Reproduction of Portion of Chart N° 1884.

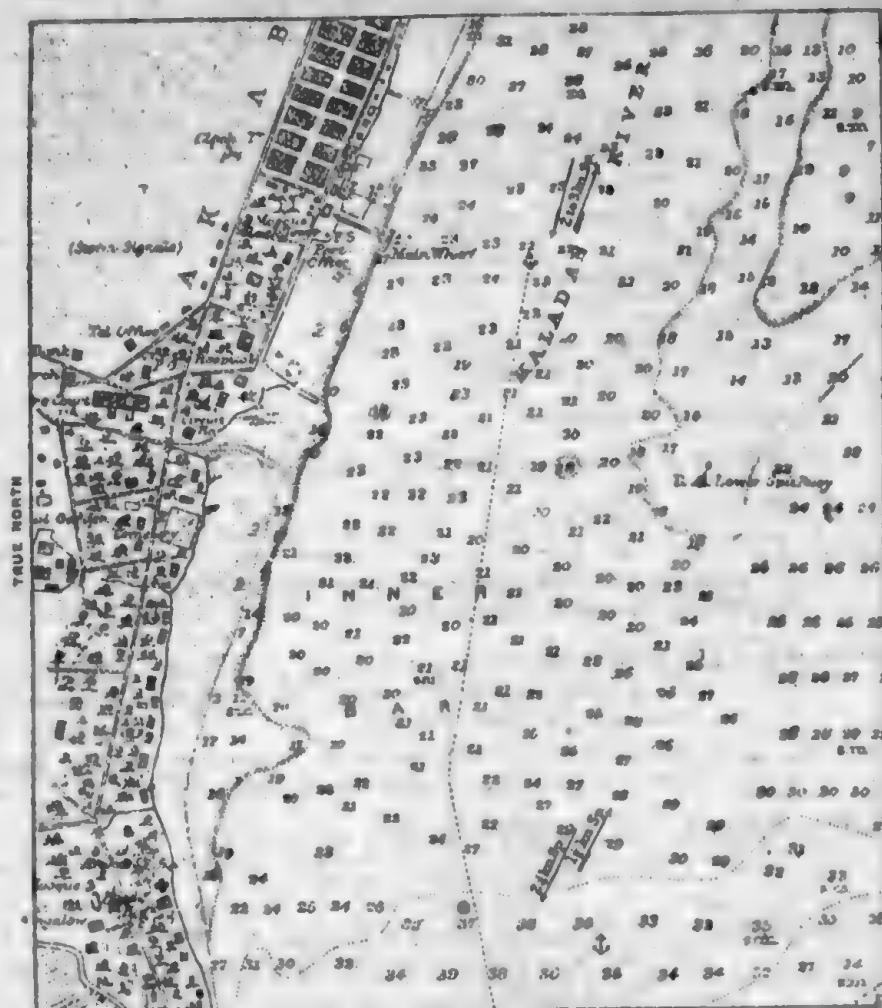
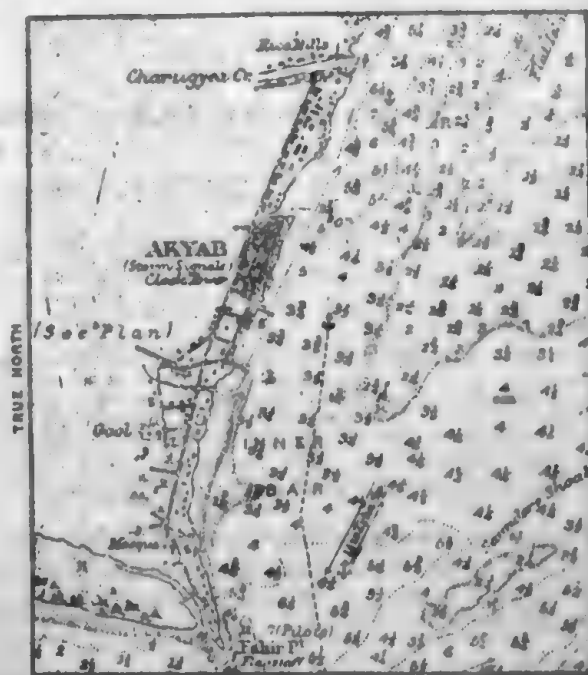
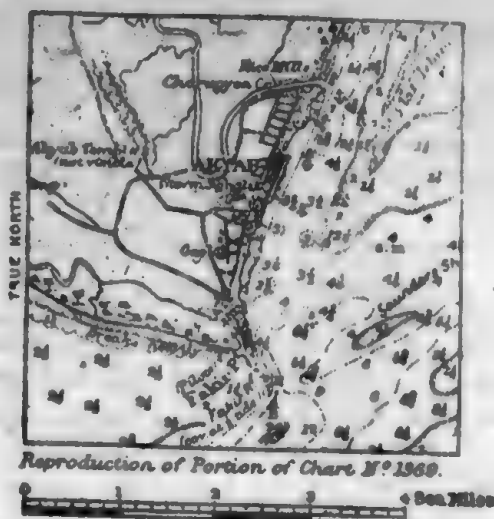
*Details*.—Amendments to the charts with regard to depths on the inner bar and vicinity, consequent upon a recent survey, are shown on the accompanying reproductions of portions of charts Nos. 1884 and 1369.

From the reproductions it will be observed that a general decrease in depths has taken place; the survey, as shown, revealed a least depth of 20 feet (6 = 1) on the inner bar April 1921.

*No. 286 (second publication).—The following particulars, etc., relative to the above, issued by the British Admiralty (No. 1046 of 1921), are republished:—*

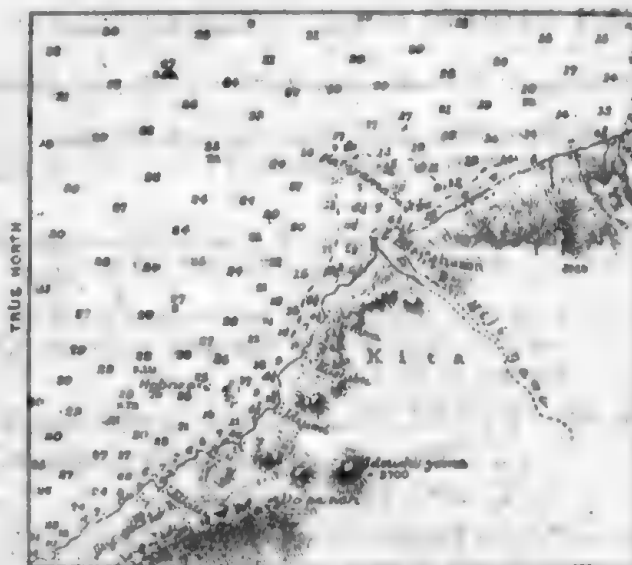
*Details.*—The accompanying reproduction of portions of charts Nos. 2875 and 1648 shows the necessary corrections to those charts with regard to depths, shoals and the coast line in the vicinity of Nagahama and approach.

*Charts affected.*—No. 934, Plan of Saubi road.

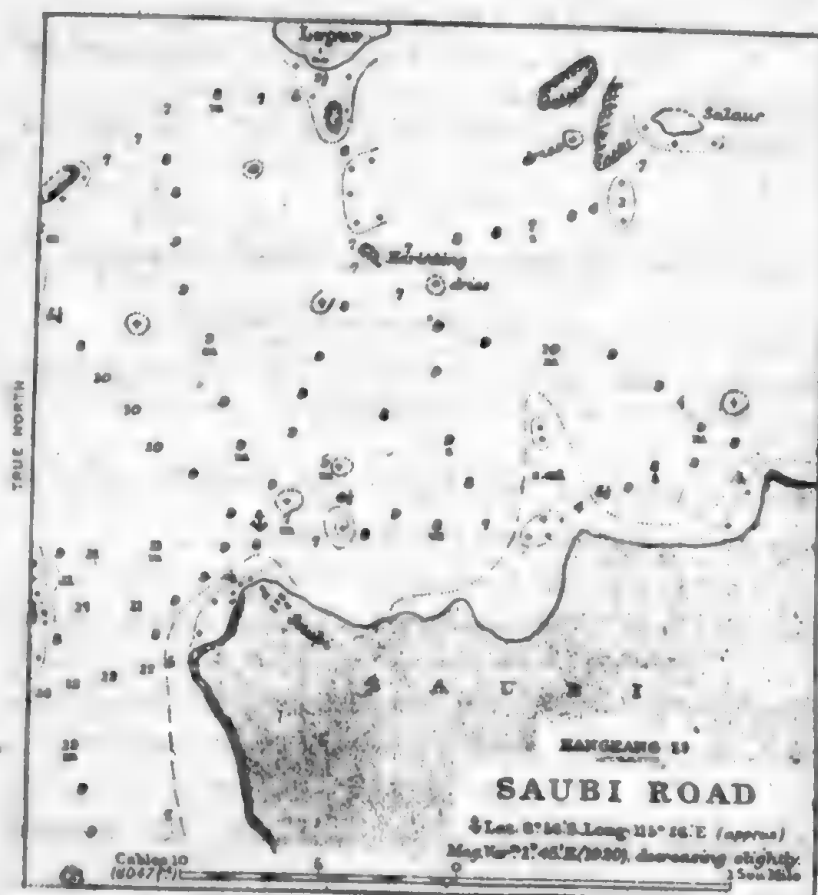
(b) A 2-fathom (3m) shoal westward of Saubi island.

Reproduction of Portion of Chart No. 3772

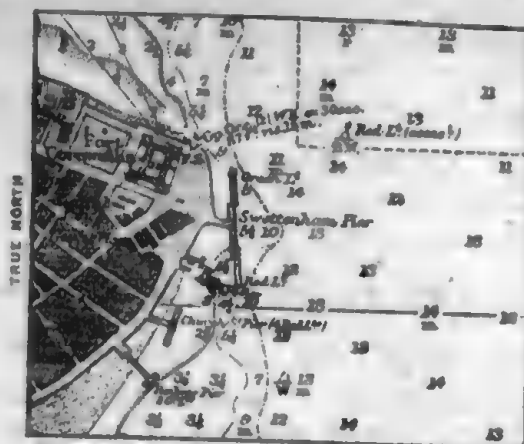
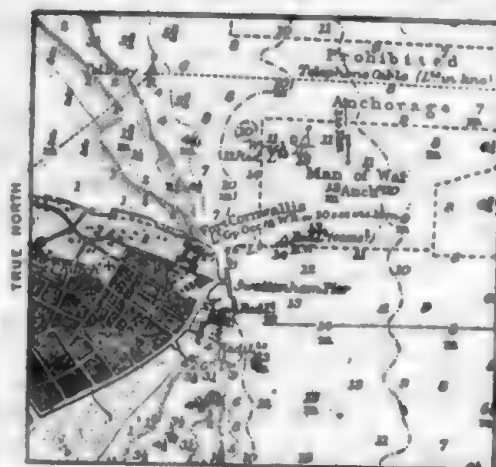
*Details.*—The accompanying reproduction of portions of charts Nos. 3732 and 1366 shows the necessary corrections to those charts with regard to Swettenham pier, the positions of the pier lights, and the alteration in position of the buoys in the vicinity of the pier.

**Chart affected.**—No. 1999, Ports Lyttelton and Levy, and Pigeon bay, with plan.

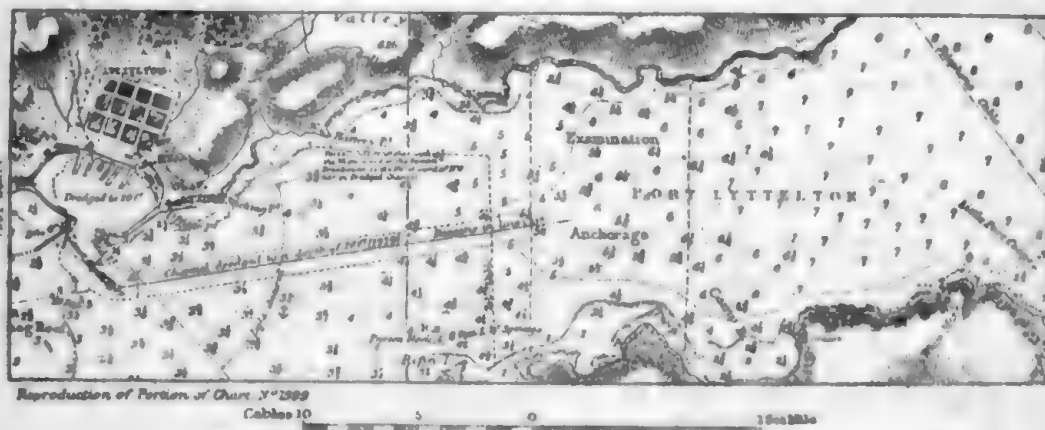
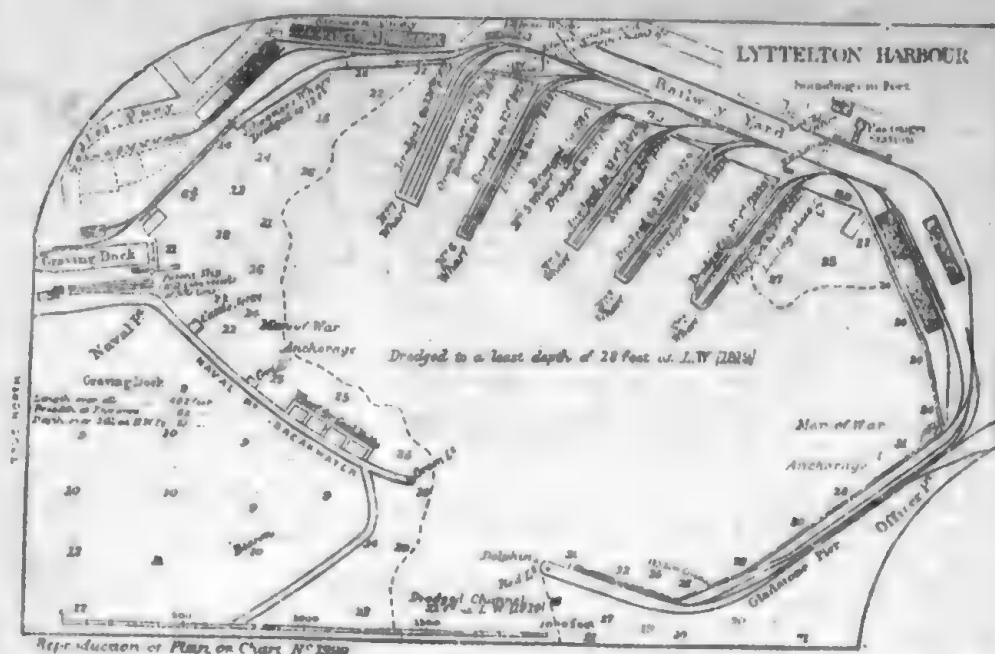
**Details.**—The accompanying reproductions of portions of chart No. 1999, show the necessary corrections to that chart with regard to the depths in Lyttelton harbour and the entrance channel.

**Remarks.**—It will be observed that extensions have been made to Nos. 5 and 6 wharves, and that two buoys have been established near the harbour entrance.

*Charts affected.*—No. 2747, Entrance to Port Phillip.

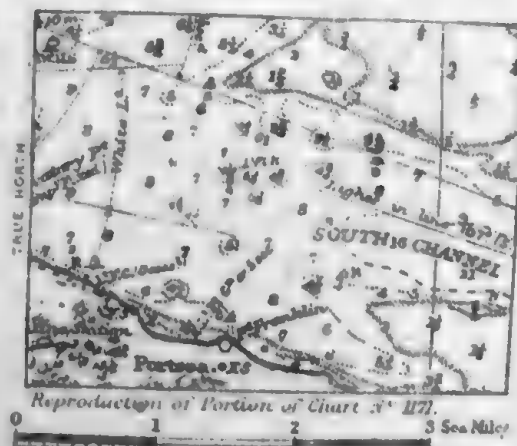
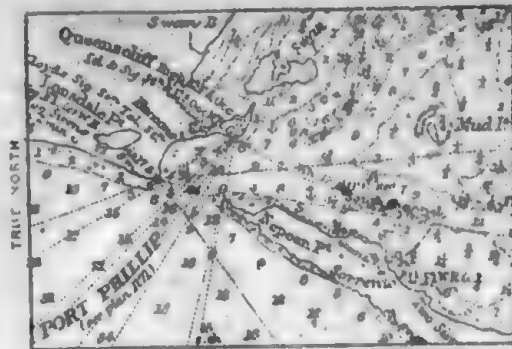
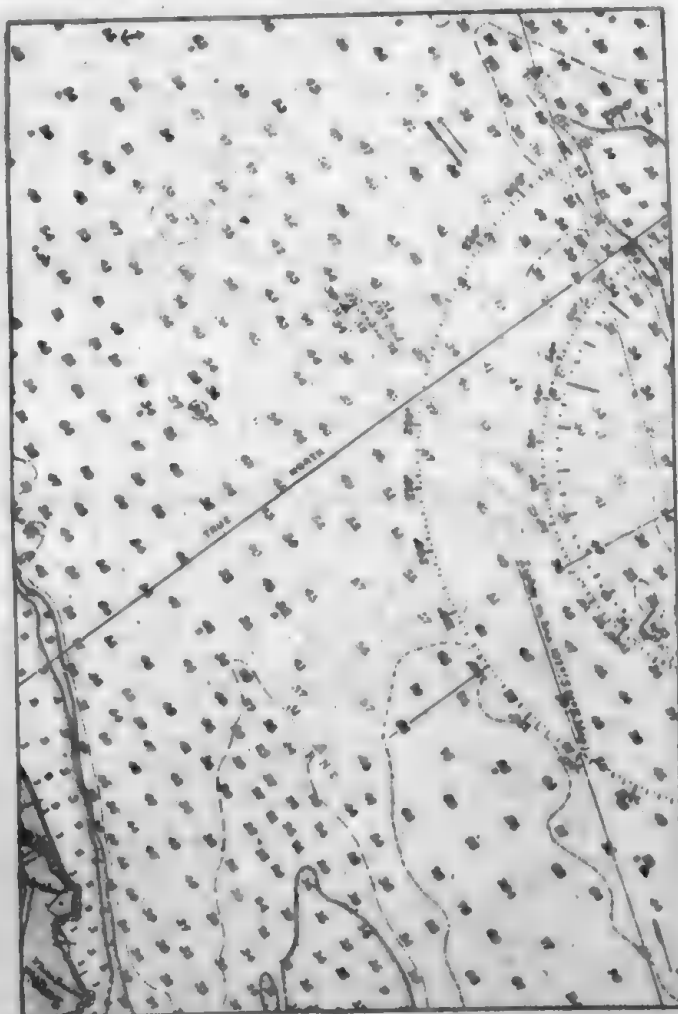
*Details.*—The accompanying reproductions of portions of charts Nos. 2747, 1171 and 1695b show the necessary correction to those charts with regard to alterations in depths in the South channel northward of Portsea.

From the reproductions it will also be seen that the positions of the light-buoy, Nos. 1, 2 and 3 buoys, and the buoy eastward of Portsea jetty have been slightly amended.

Reproduction of Portion of Chart N°3720.

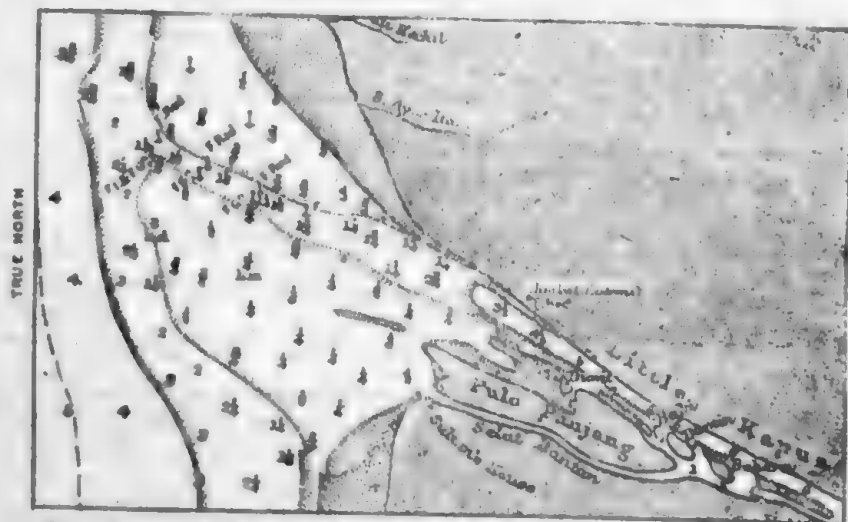
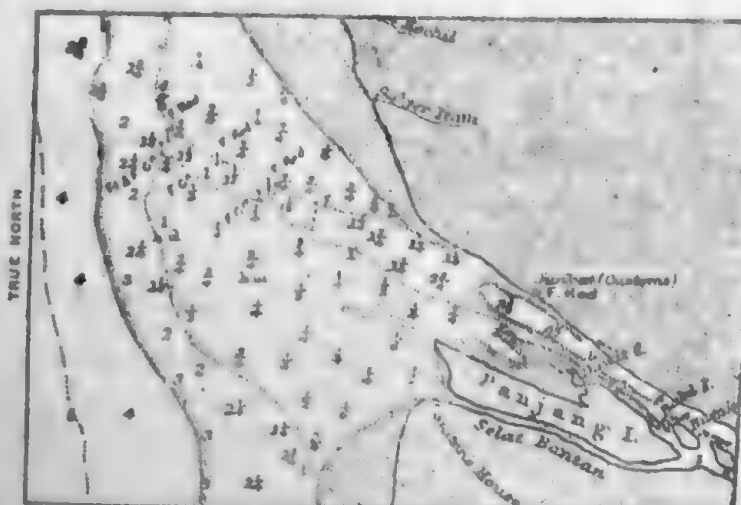
*Details.*—The accompanying reproduction of portions of charts Nos. 3720 and 3721 shows the necessary corrections to those charts with regard to depths, &c., in the entrance to Little Kapuas river, together with the amended position of the fixed red light at Junkat.

*Charts affected.*—No. 3440, Plan of Katapu anchorage.  
 „ 3744, Tanjong Suabur to Kabu islands, etc.  
 „ 3745, Kabu islands to Tanjong Kasbi, etc. (2).  
 „ 9426, Eastern archipelago—sheet IV.

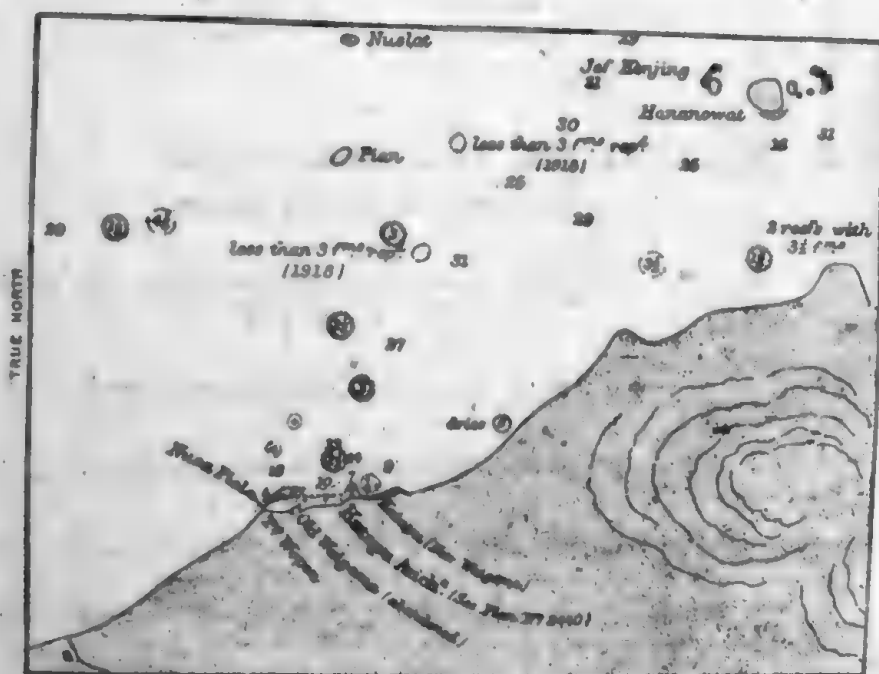
The inner 2½ fathom shoal, which is situated at a distance of 13.05 cables,  $063^{\circ}$ , from the centre of Nusa Piat, is to be inserted on the plan of the abovementioned anchorage on chart No. 3440.

*No. 308 (first publication).*—The following particulars, etc., relative to the above, issued by the British Admiralty (No. 1133 of 1921), are republished :—

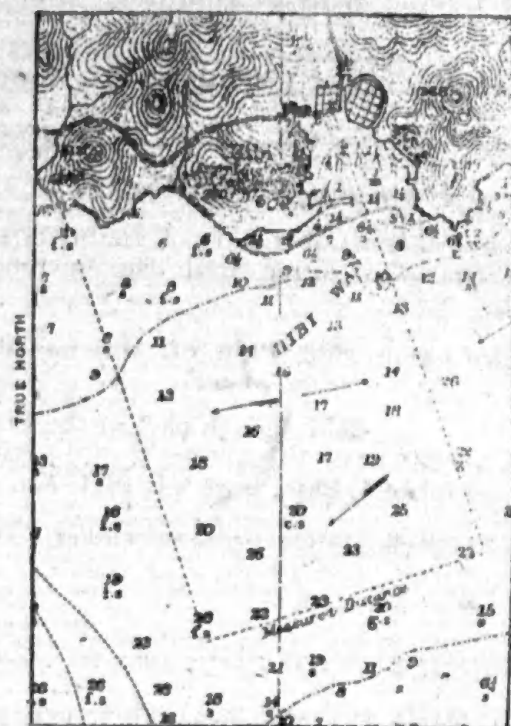
*Details.*—The harbour works at Hibi wan have now been completed and a measured distance, indicated by beacons, has been established as shown on the accompanying reproduction of portions of charts Nos. 1969 and 128.
